METROPOLITAN GOVERNMENT OF NASHVILLE AND DAVIDSON COUNTY

STAFF RECOMMENDATION
2218 Grantland Avenue
March 17, 2021

Application: New Construction—Addition
District: Woodland in Waverly Historic Preservation Zoning Overlay
Council District: 17
Map and Parcel Number: 10514011200
Applicant: Brittney Blanton, Architect
Project Lead: Sean Alexander, sean.alexander@nashville.gov

MAIN LEVEL FLOOR PLAN

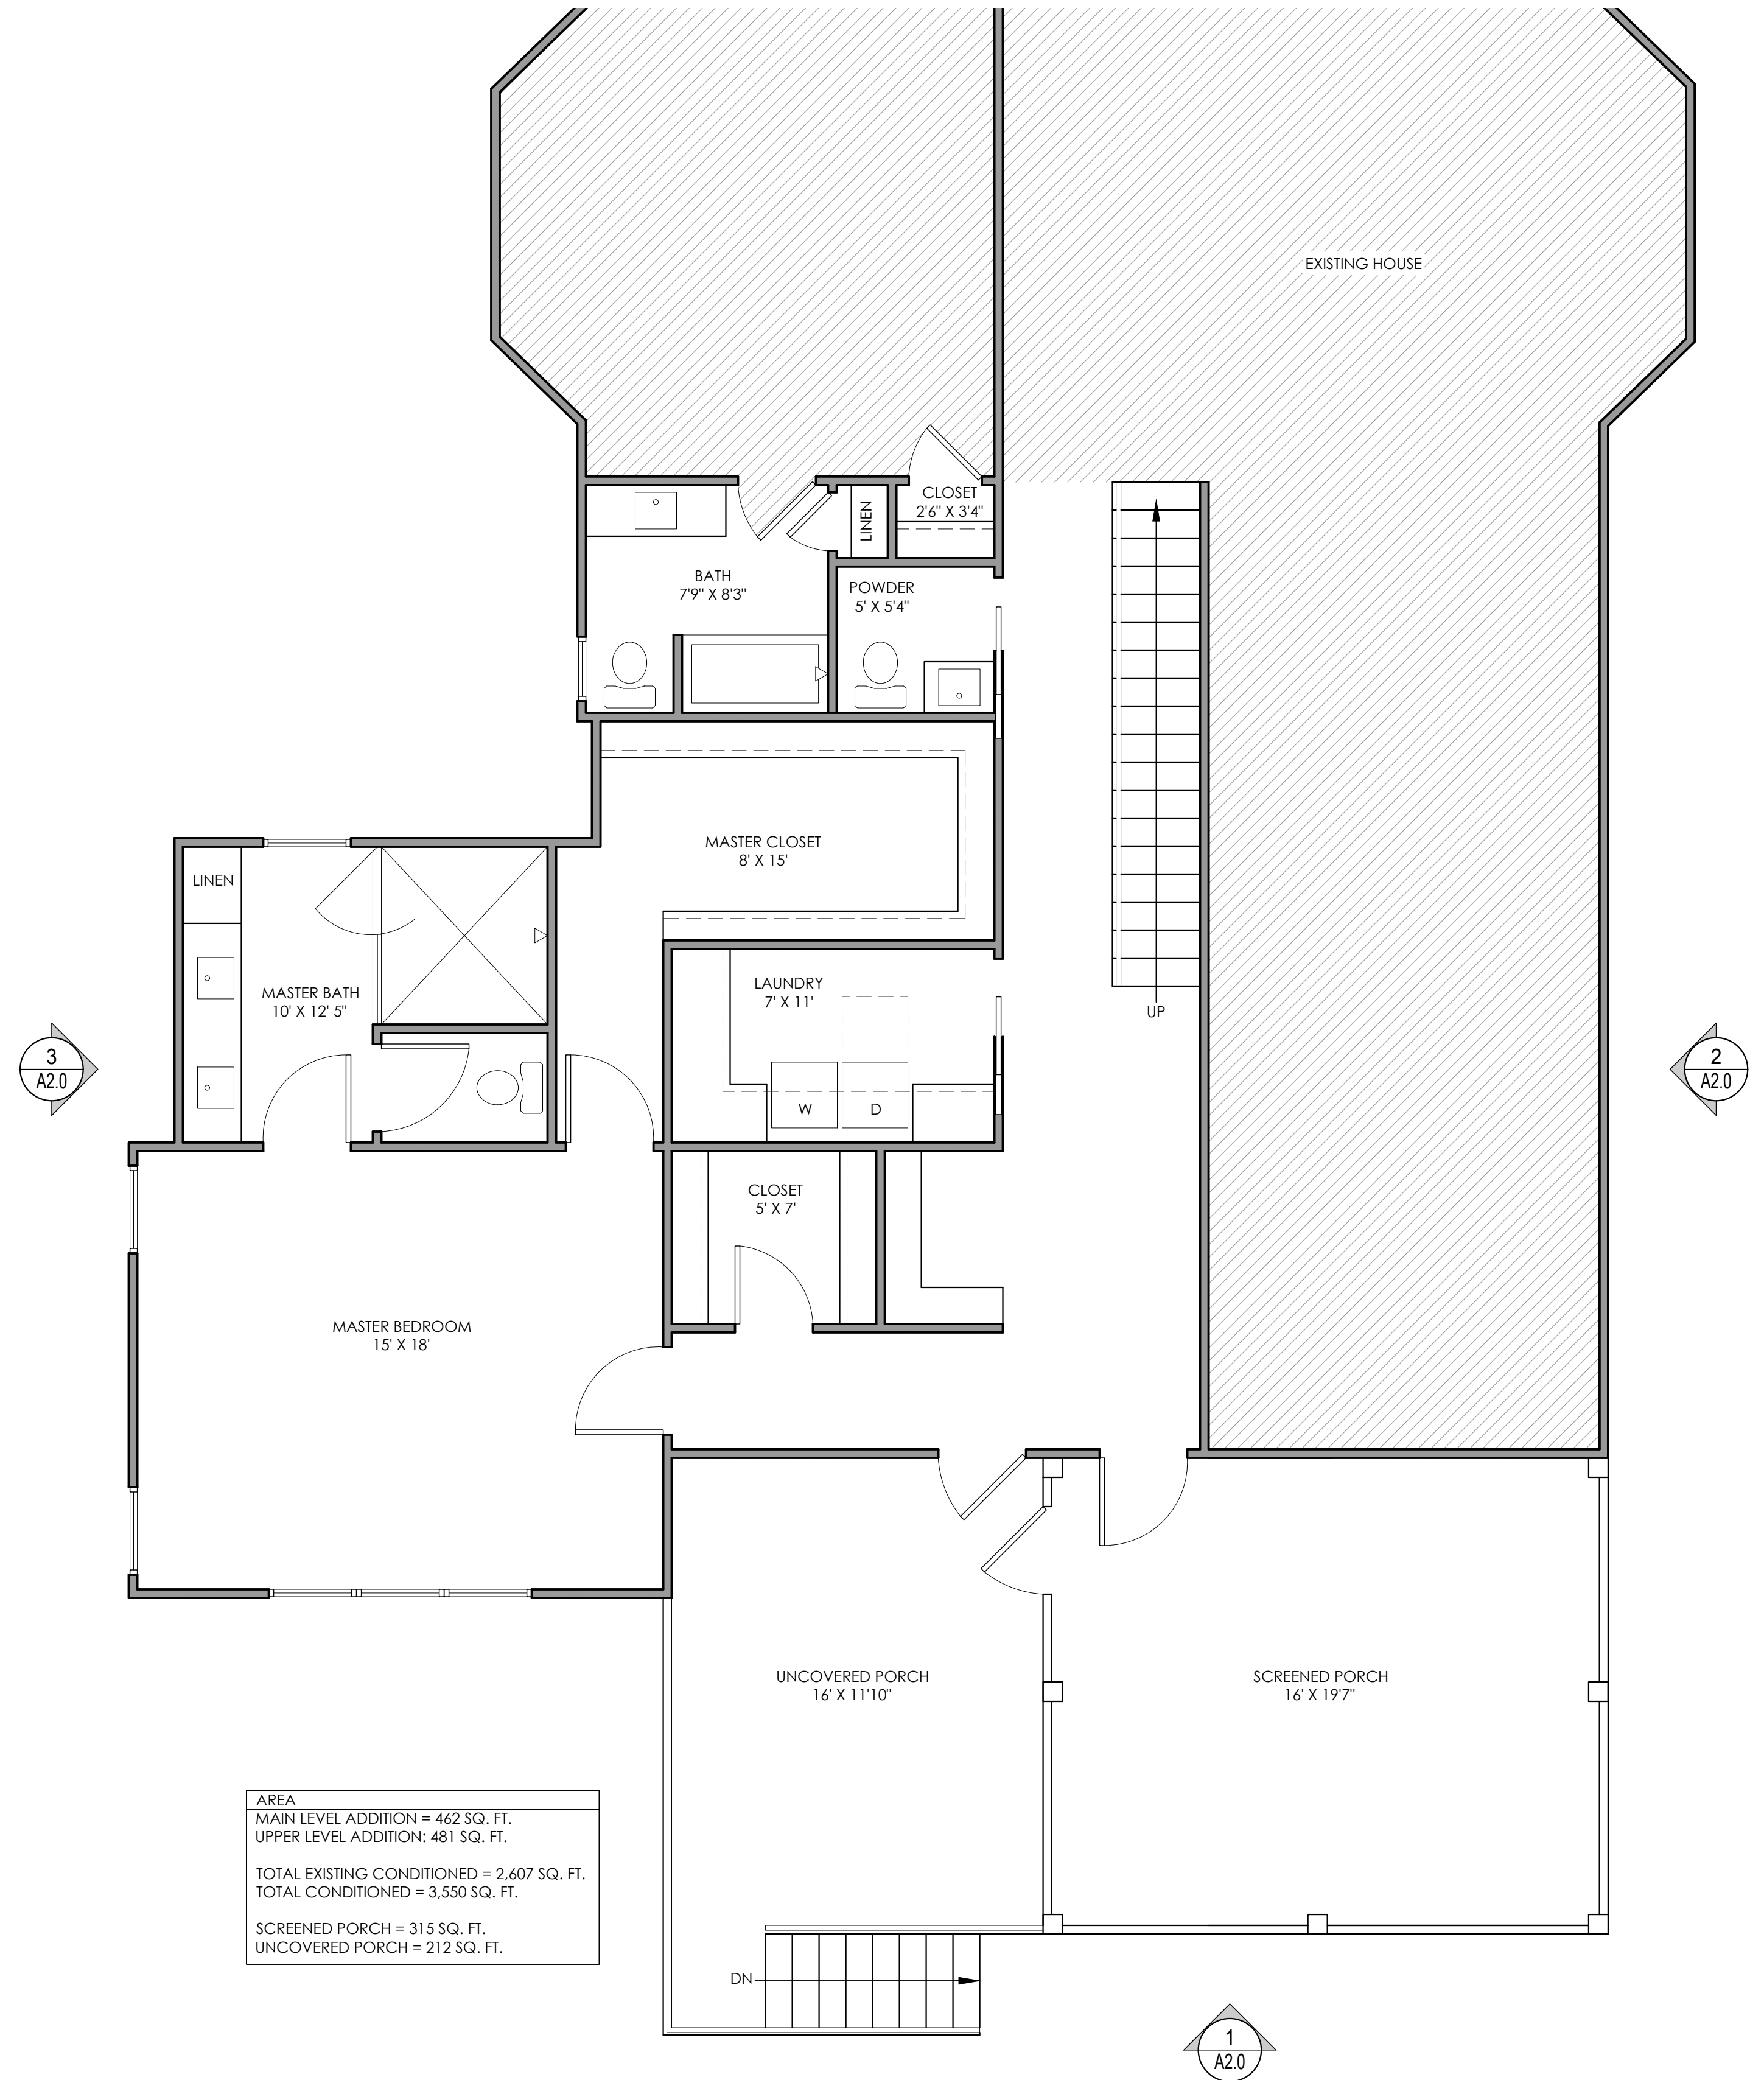
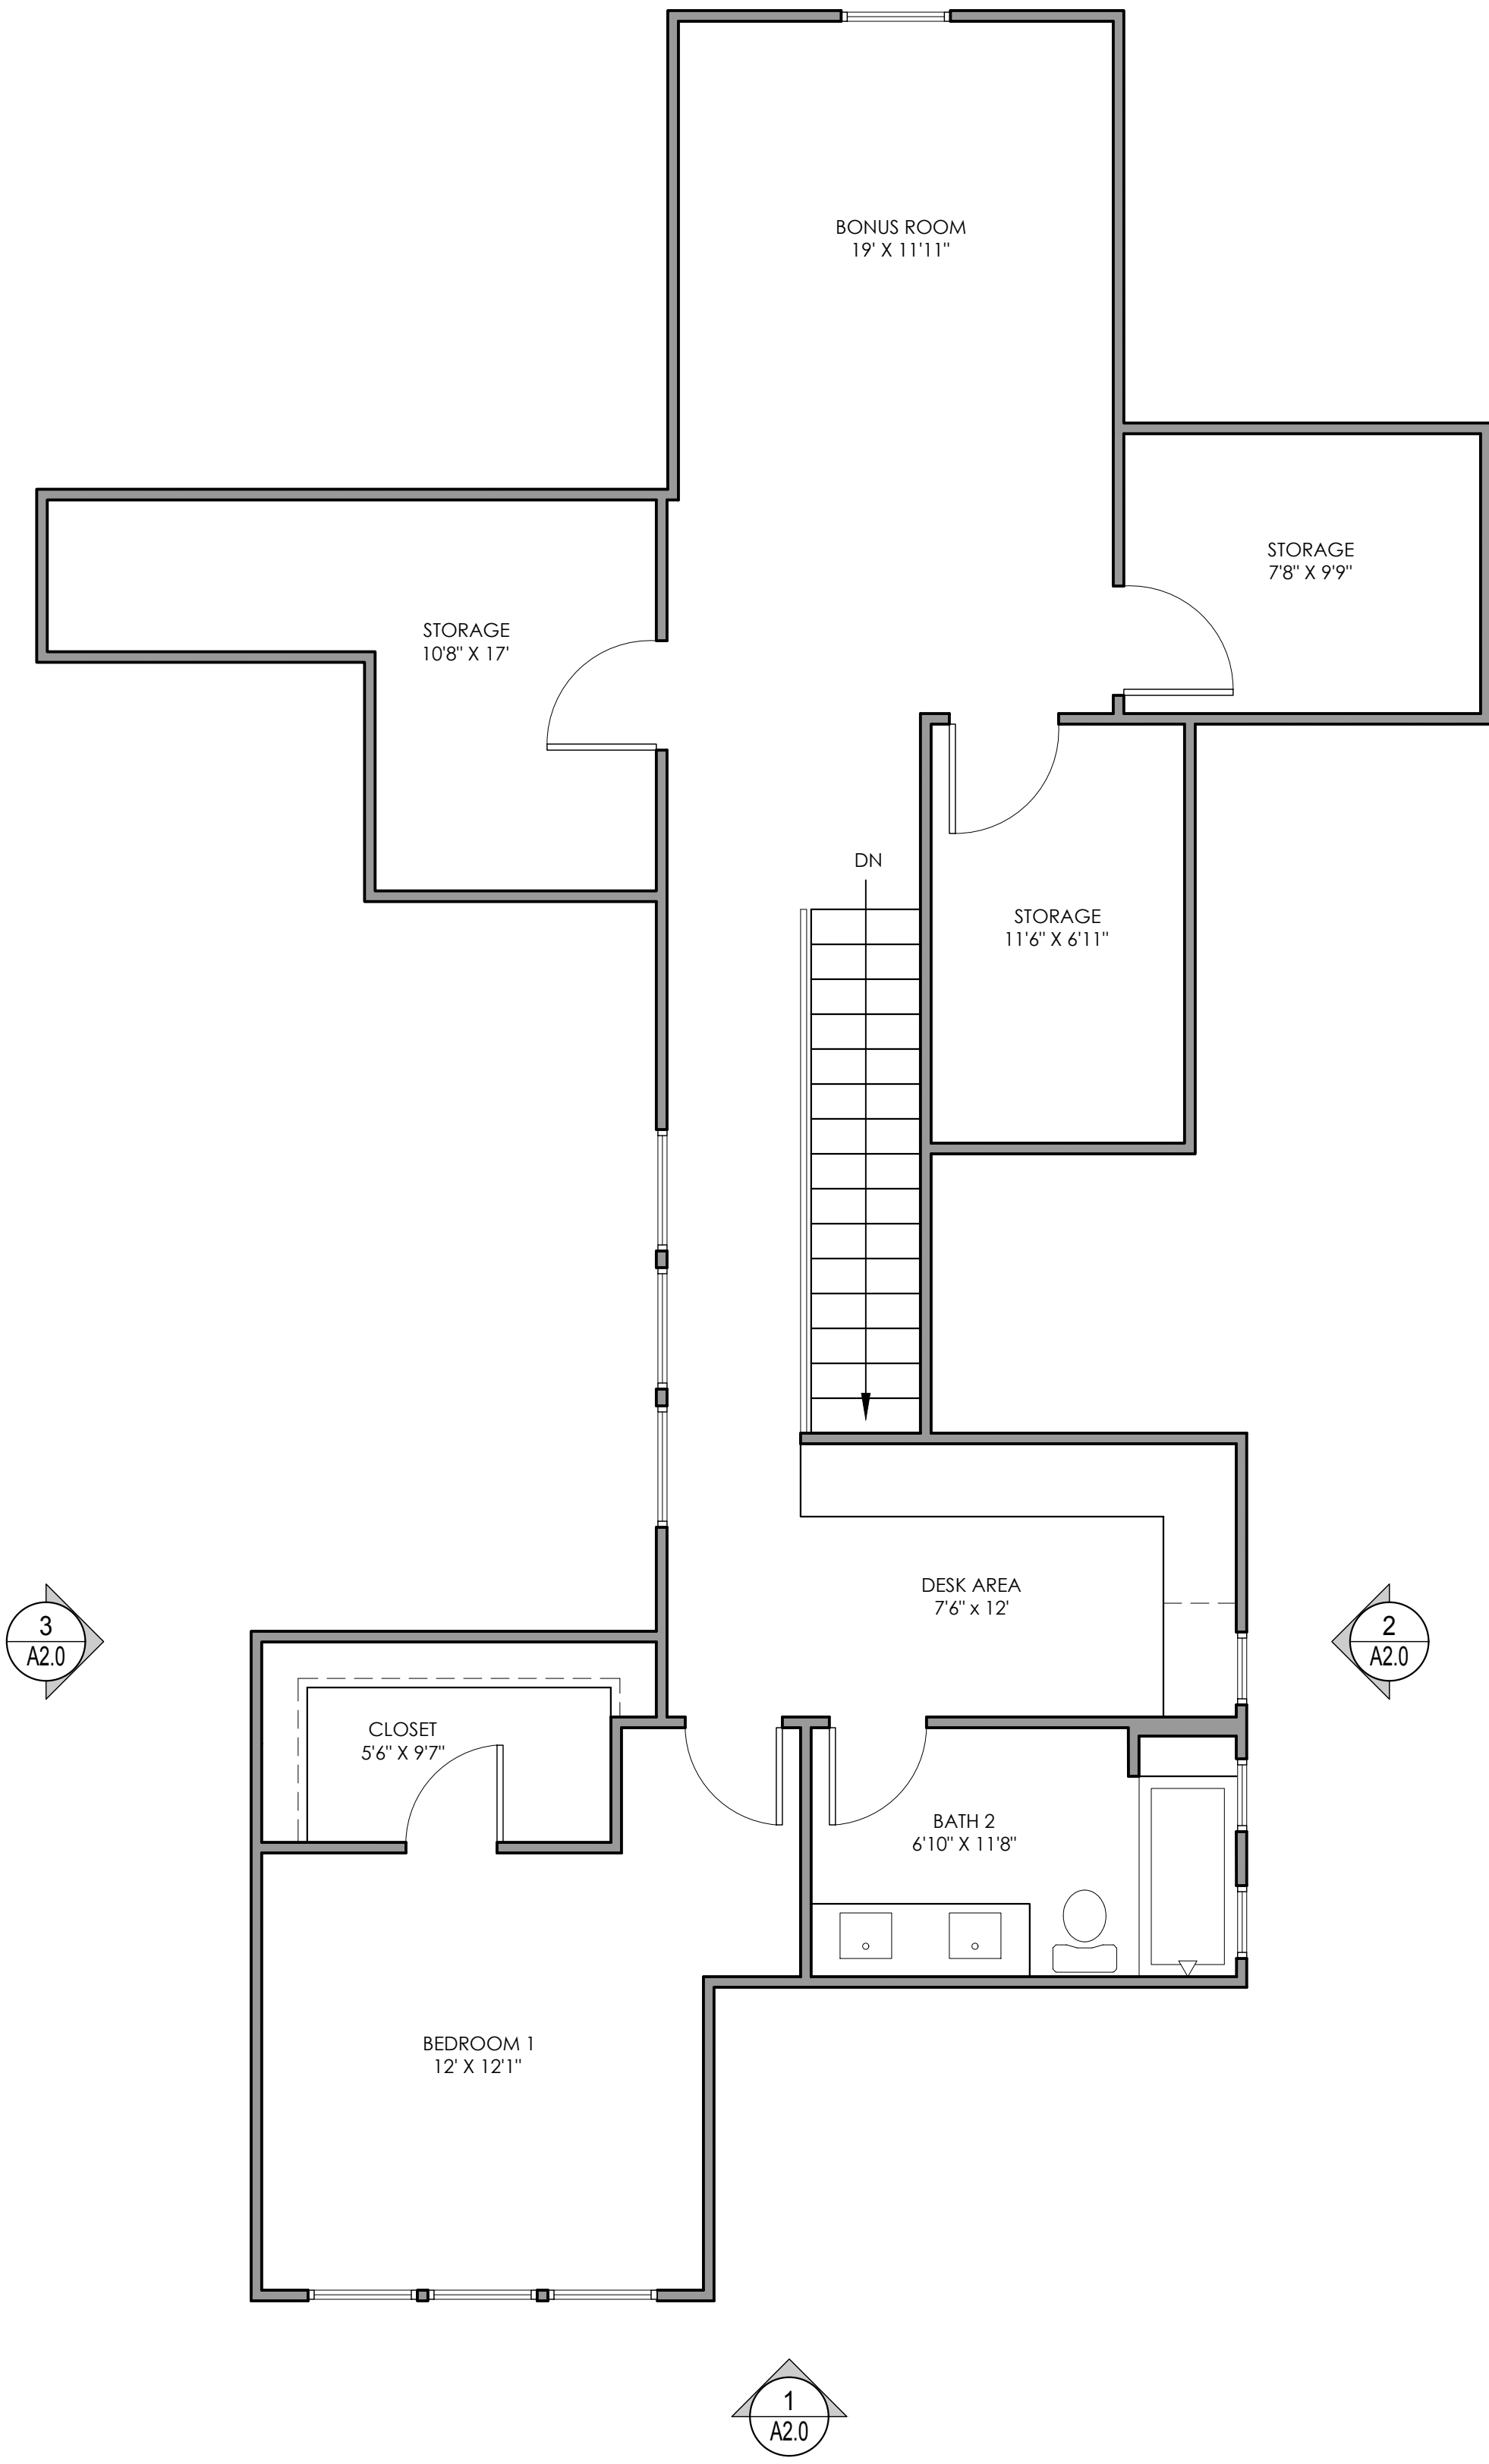
Location and Removability: The rear addition will be one story tall, stepped in six inches (6") from the primary side wall of the house on the right side before going back, then stepping out fourteen feet (14') to the right. On the left side the wall of the addition will not be stepped in, tying in flush with the existing side wall. Additions are typically required to step in at least one foot (1') in order to preserve the integrity of an historic house form, however the rear of this structure was altered by the previous addition that does not step in from the left side and wraps the right-rear corner. The roof of the addition will be stepped in so as to not impact the original roof form.

Staff finds the location of the proposed rear addition and the general character of the design to be compatible with the historic house, and that it will meet sections III.B.1.a and III.B.1.d of the design guidelines for additions.

Height, Scale: As the rear addition extends back, after stepping in for a span of four feet (4'), it will step out and expand in fourteen feet (14') wider to the right. The additional width is less than half the width of the historic house. The wider portion of the addition will have a side-gabled roof matching the ridge and eave heights of the historic houses. Although additions should generally be behind an historic house, staff finds that the addition width is appropriate because the lot at 2218 Grantland Avenue is wider than the typical lot on the block, the house is off-center on the lot, and the addition is only one and one-half story with a side-gable roof form that lessens the visual impact of the half-story as seen from the street.

On the left side, the addition will match the width of the historic house. The roof of the addition will also match the ridge and eave heights of the historic house, but it will be stepped in so as to not impact the side slope or ridge of the historic form.
